**First Amendment to the Draft  
Environmental Impact Report/  
Environmental Assessment**

**KING AND DOBBIN TRANSIT  
VILLAGE AND US 101 –  
OAKLAND/MABURY  
TRANSPORTATION  
DEVELOPMENT POLICY  
(PDC07-015, NR07-002 and  
PP07-172)**

**November 2007**

FIGURE 26

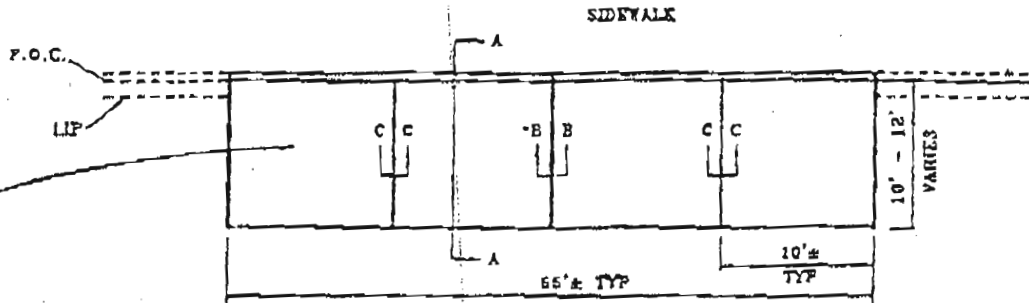
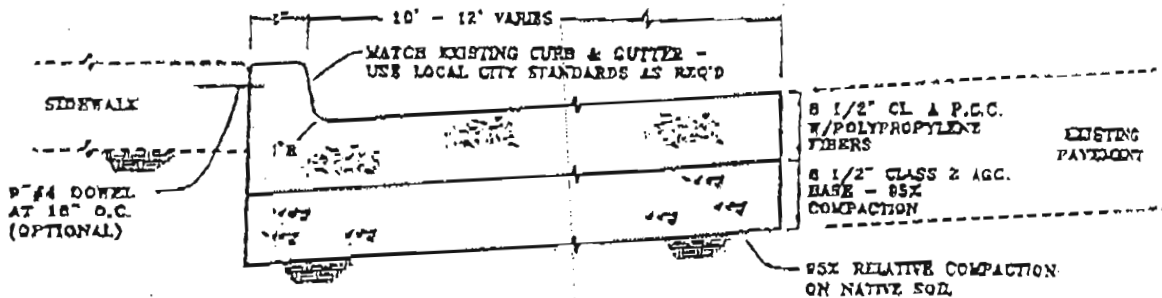
VTA provides bus service on King Road. In order to provide convenient access to transit, VTA recommends that the City condition the developer to provide a new bus stop on King Road, north of Dobbin Drive.

- Provide an 8' X 55' PCC passenger waiting pad consistent with VTA standards (attached).
- Provide an 8' X 40' passenger waiting pad, with no trees or planters in the area to interfere with boarding of passengers.

**RESPONSE F-1:**     The VTA's request for a bus stop designed to their specifications is acknowledged. The project site is served by several bus stops at the intersection of North King Road and Mabury Road, and at the intersection of North King Road and Las Plumas Avenue. The bus stops are within adequate walking distance of the project site. The provision of a bus stop along the project frontage is not required to mitigate the significant transportation impacts of the project; however, the VTA's request for a bus stop will be considered by the City as it conditions the project at the Planned Development Permit stage.
